DESCRIPTIVE REPORT

Registry No. H-11108

General Locality Peril Strait

Descriptive Report to Accompany Hydrographic Survey H11108

Figure 2. H11108 Junction Surveys.

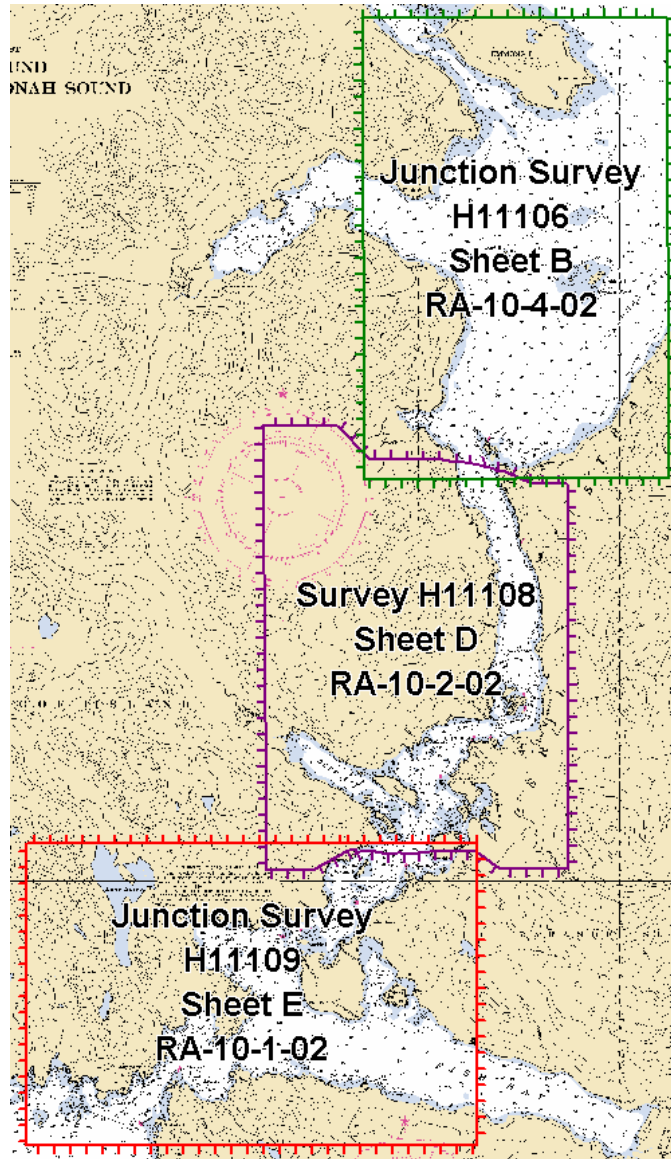
Survey H11106 junctions well with this survey, a cursory comparison indicates differences are generally less than one fathom.⁵

Survey H11109 junctions well with this survey, a cursory comparison indicates differences are generally less than one fathom.⁶

⁵ Concur, the junction with H11106 was not formally completed since this survey was processed previously. However, the standard depth curves on the present survey were drawn considering both data sets and therefore should be used with the common area. An "Adjoins" note have been added to the smooth sheet.

⁶ The junction with survey H11108 and survey H11109 are complete. A "Joins" note has been added to the smooth sheets where applicable.
